# Access Compliance Report

## Public Rights-of-Way

Intersection ID: 51059	Main Street: CORY-BRET_LN	Cross Street: CRAIGMOSS_LN	Location: NE
ADA ID: 28015C80B471	Ramp Type: PerpDiag	Initial Pass/Fail: Fail	Overall Compliance: No
		Severity Score: 12.5

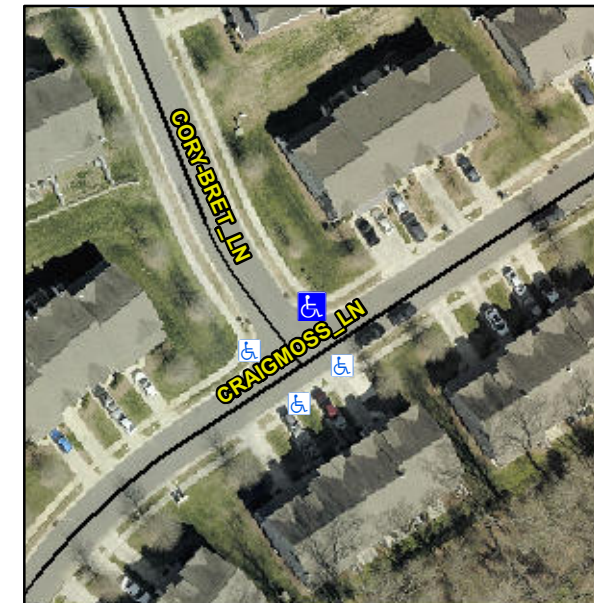
**Not Found, R304.2.2**

Compliance	Description	Data	Compliance	Description	Data
N/A	Ramp Length (in)	48.0	No	Ramp Slope (%)	8.6
Yes	Ramp Width (in)	48.0	Yes	Ramp XSlope (%)	2.0
N/A	Flare Type LT	N/A	N/A	Flare Type RT	N/A
N/A	Flare Slope LT (%)	N/A	N/A	Flare Slope RT (%)	N/A
N/A	Flare Traversable LT?	N/A	N/A	Flare Traversable RT?	N/A
N/A	Landing Length (in)	N/A	N/A	DWS Provided?	N/A
N/A	Landing Width (in)	N/A	N/A	DWS Contrast?	N/A
N/A	Landing Slope (%)	N/A	N/A	DWS Length (in)	N/A
N/A	Landing X Slope (%)	N/A	N/A	DWS Full Width?	N/A
N/A	Landing Curb? (Y/N)	N/A	N/A	DWS Offset (in)	N/A
N/A	Shared Landing?	N/A			
N/A	Gutter Ponding?	N/A	N/A	Gutter Slope (%)	N/A
N/A	Gutter Lip Ht (in)	N/A	N/A	Gutter X Slope (%)	N/A
N/A	Painted X Walk1?	No	N/A	Painted X Walk2?	No
	X Walk 1 Direction	To SW		X Walk 2 Direction	To SE
N/A	X Walk 1 Width (in)	N/A	N/A	X Walk 2 Width (in)	N/A
	X Walk 1 Slope (%)	0.3		X Walk 2 Slope (%)	0.5
	X Walk 1 X Slope (%)	0.7		X Walk 2 X Slope (%)	0.7

**Remove & Replace Curb Ramp With Two New Directional Ramps or Equivalent.**
